C2C return loss

Piers Dawe

Some related issues with C2C spec

Showing various return loss limits

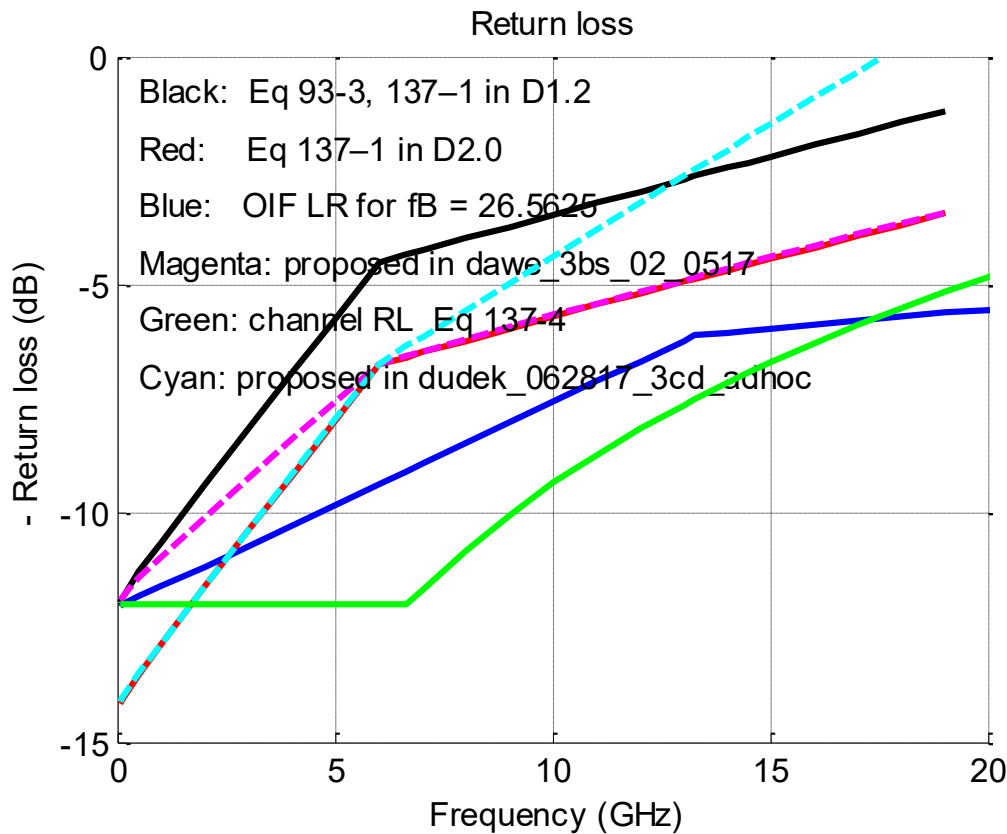
- Compare previous slide
- See next slide for simpler view
- Red and cyan are too tight at low f
- Cyan is too loose at high f
- Black is too loose at mid f
- Green – channel (later slides show more about the channel RL)

Focus on Tx, Rx RL

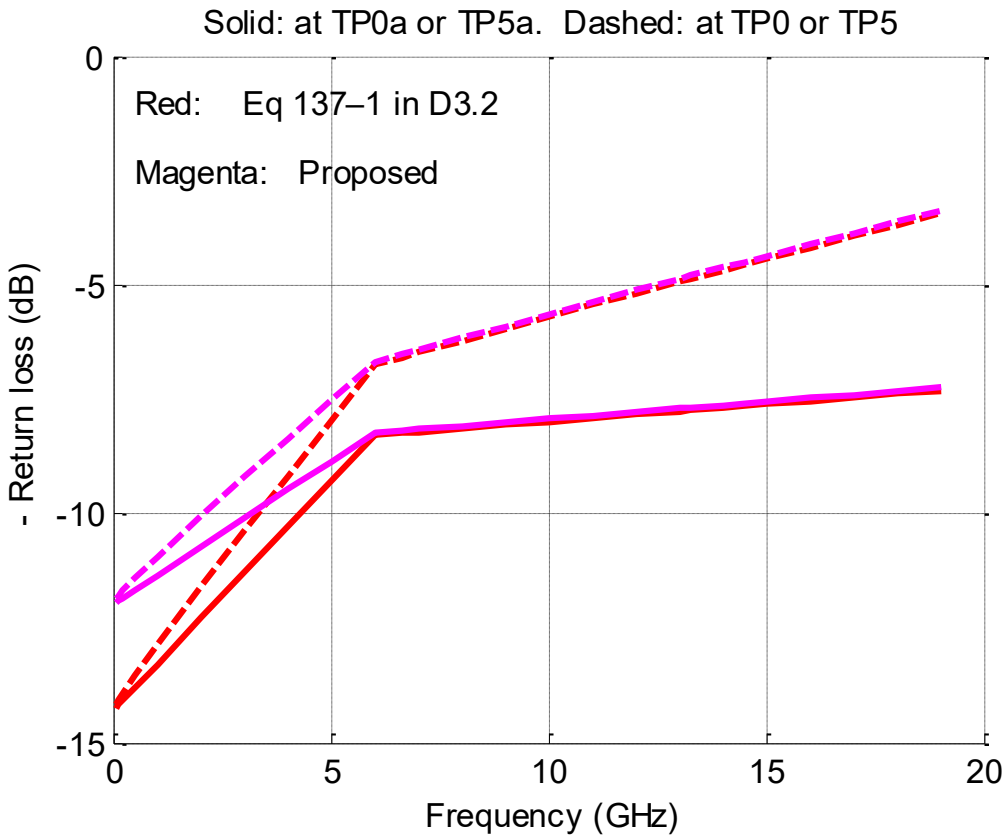
- Red is too tight at low f

Summary so far

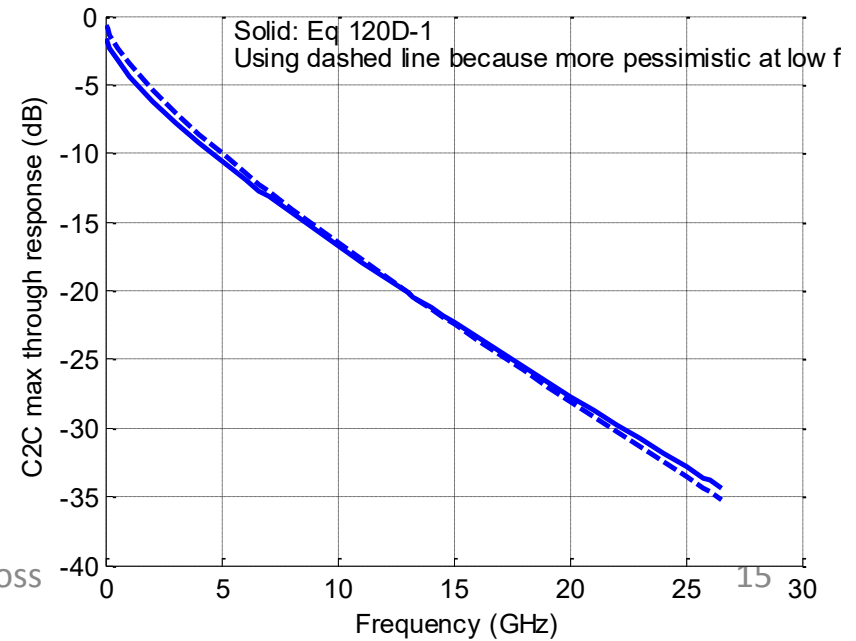
- The low frequency reflections between Tx and channel or Rx and channel are negligible – higher frequency reflections dominate
- Reflections between Rx and nominal channel are in RITT anyway – only some of the Rx-channel reflection needs to be bounded by the RL specs, the other part is in the test
- But, what about end-to-end reflections?

The echo, which is what matters, is caused by two reflections

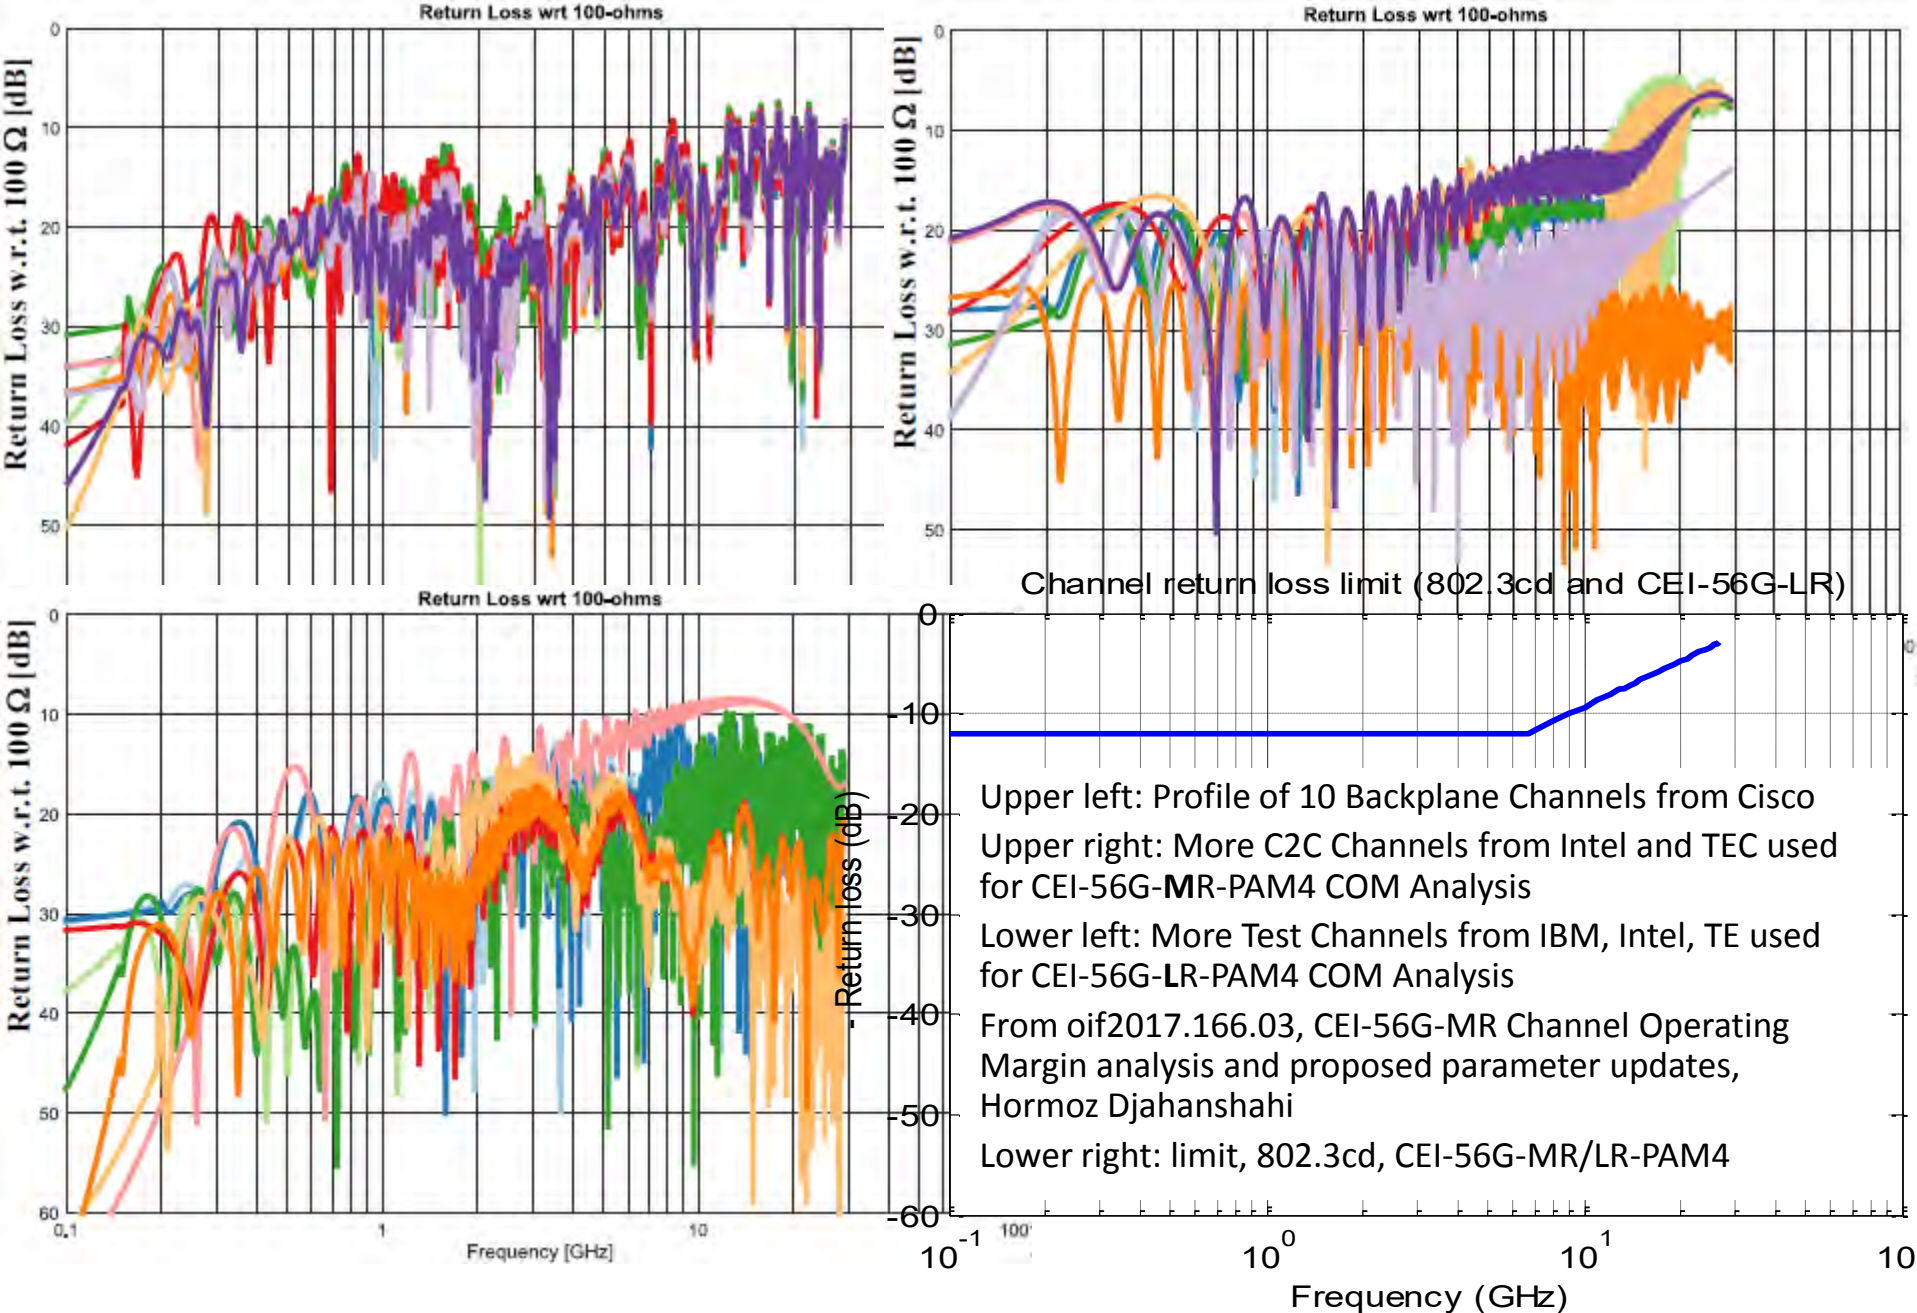
- Multiplying (Tx or Rx) reflection by channel through response squared
- Same voltage scale as two slides before
- Receiver boosts high frequencies
 - and attenuates beyond Nyquist
- For high loss channels, the end-to-end reflections are much smaller than the end-channel reflections

It appears that channel RL will be much better than spec << 1 GHz

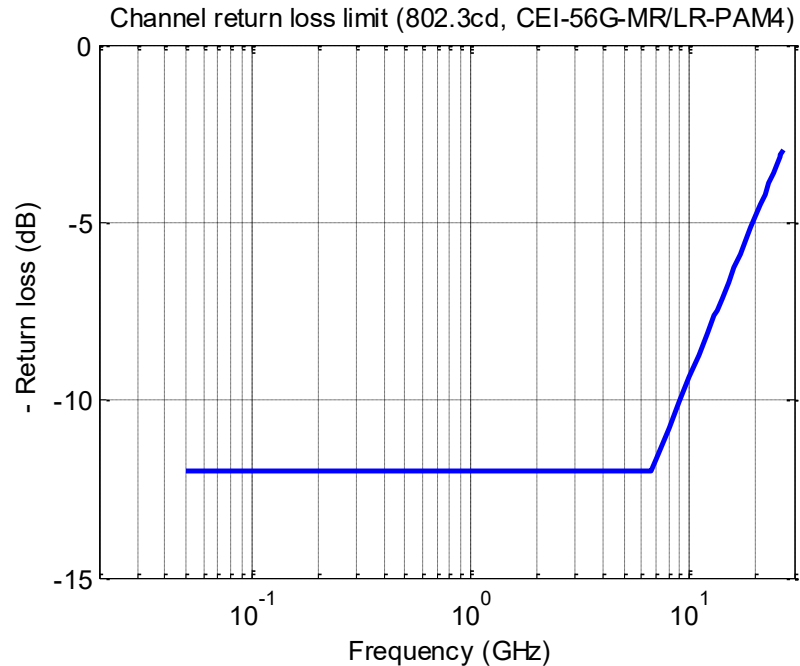
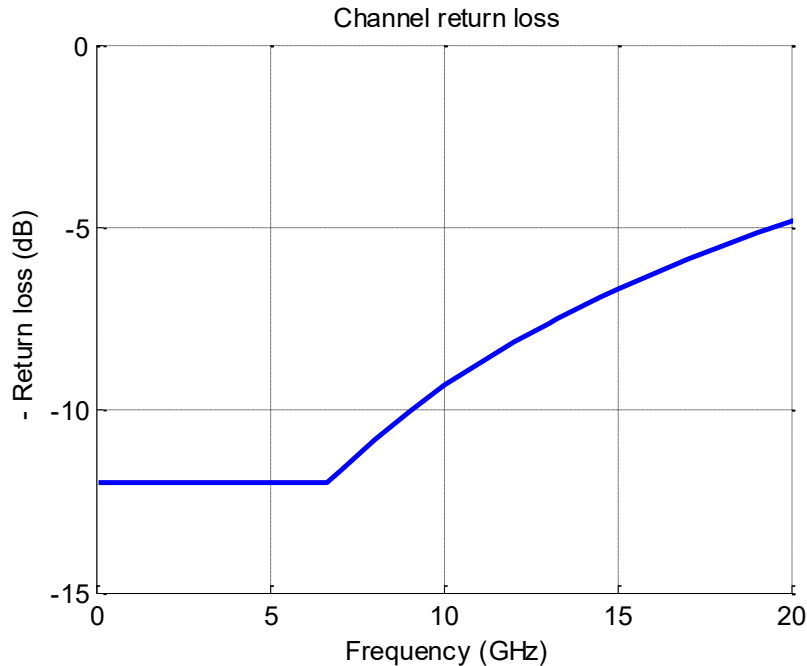
- Channel return loss (at TP0 or TP5) from 802.3bs Eq. 120D-12, 802.3cd Eq. 137-4
- Also OIF CEI-56G-MR-PAM4 Eq 17-3 and LR-PAM4 Eq 21-3
